We are hereby requesting a discussion on an item on the Agenda of November 12, 2015.

- 11. Mercury drive subdivision- Homestead Land Holdings, LLC
 - a. Concept Subdivision Plan 11-SA-15-C
 - b. Use on Review 11-G-15-UR

11-SA-15-C / 11-G-15-UR
 CONCEPT PLAN/USE ON REVIEW

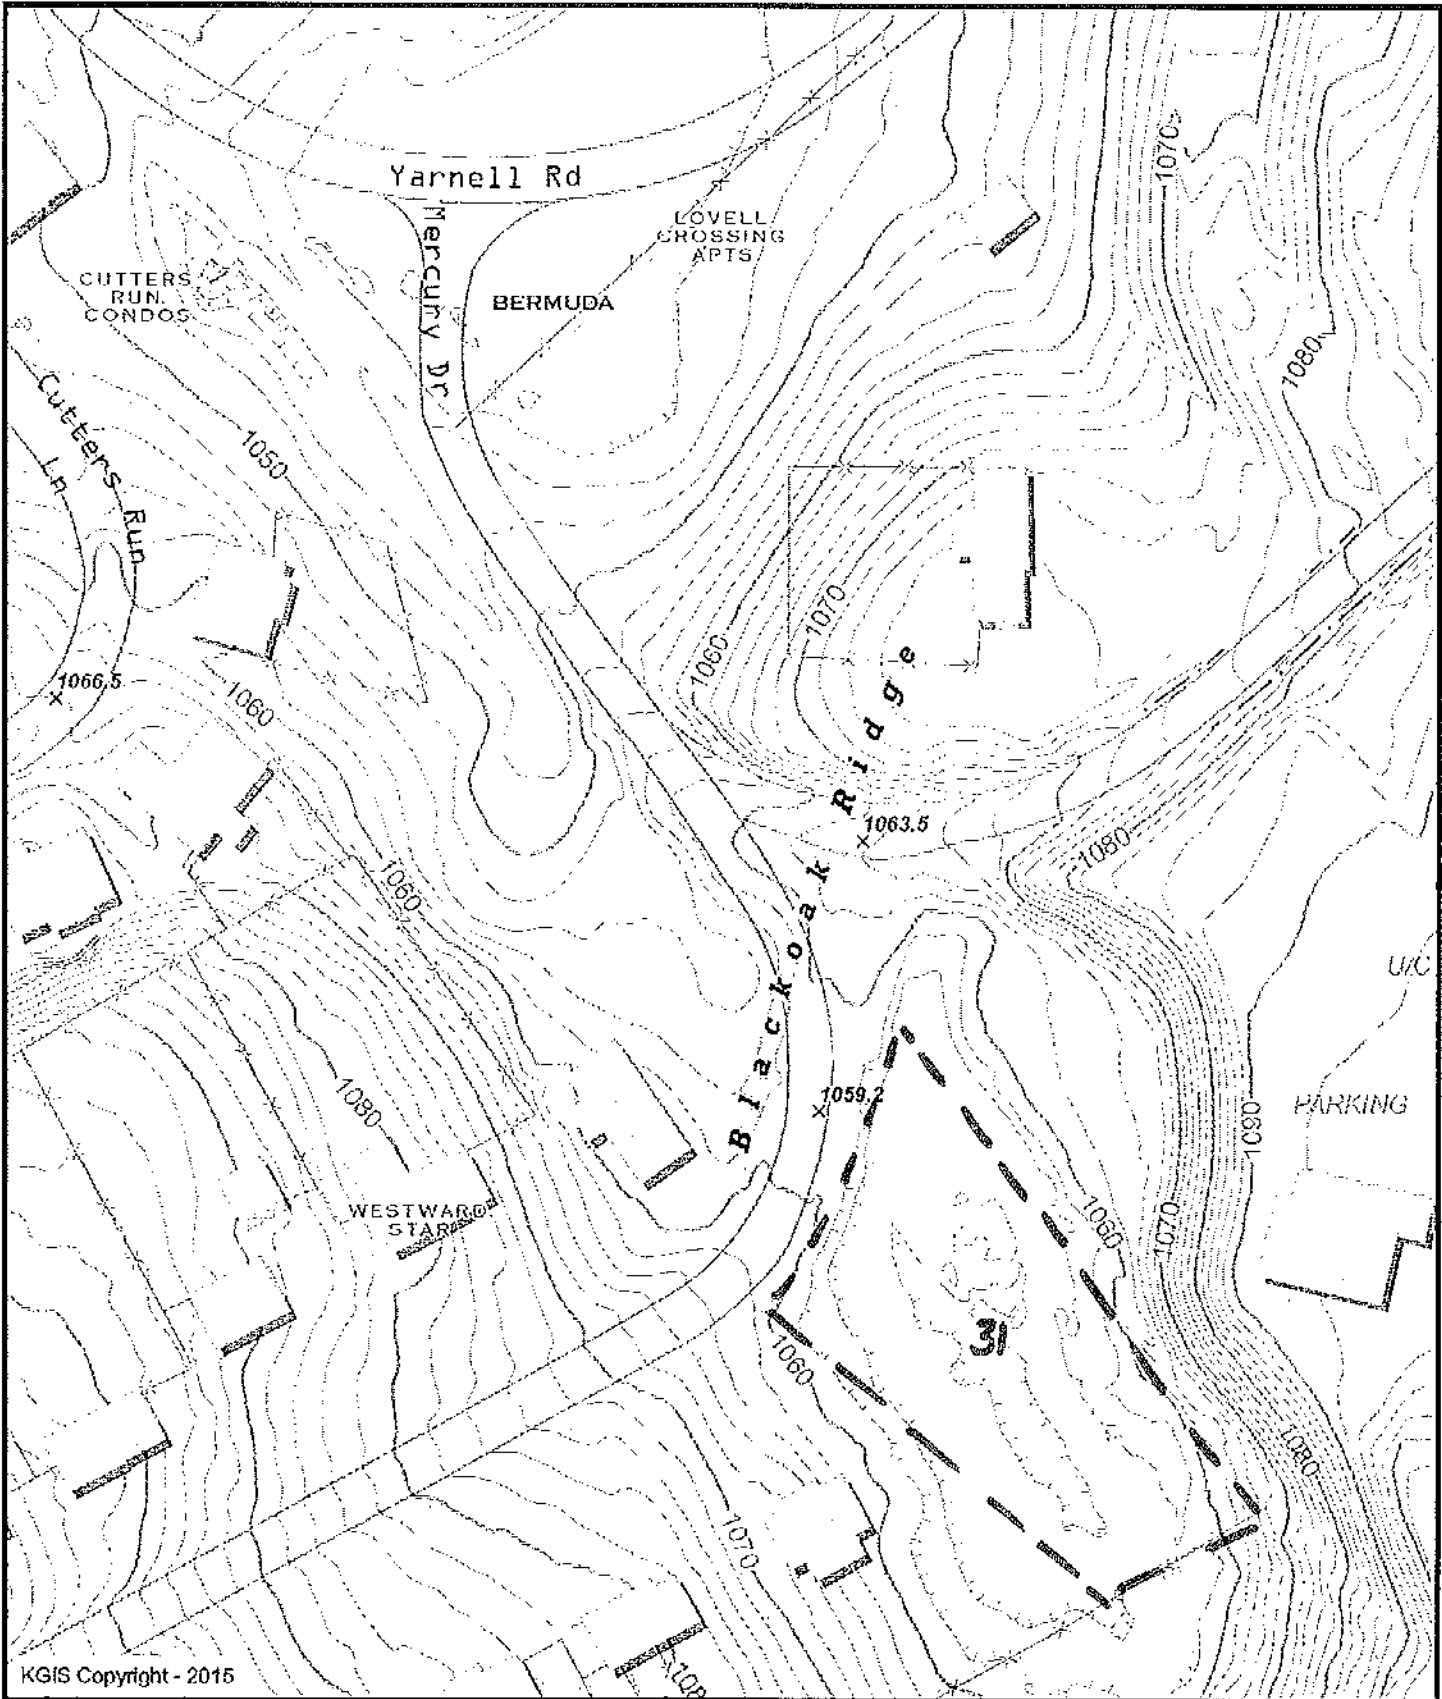
As the owner of the nearby lot on the Mercury Drive (lot 31, Parcel 118HA031), we are worried about the potential impact of the change of pattern of the storm runoff, if the existing green-space is replaced by the paved structures. We have talked to Mr. Tom Brechko (Subdivision and Development Plan Review) and Mr. Leo La Camera (Storm water Engineer, Knox County Stormwater) and understood the basic concept of the proposed subdivision plan. While a runoff detention basin closed to the Yamell Road is proposed, the impact of the landscaping on the Mercury Drive is not apparent. Given that Mercury Drive is lower than the proposed subdivision, we would therefore like to request a specific discussion of this concern. The potential risk of flooding of our lot and the nearby Mercury Drive should be avoided and be considered in the planning of original concept.
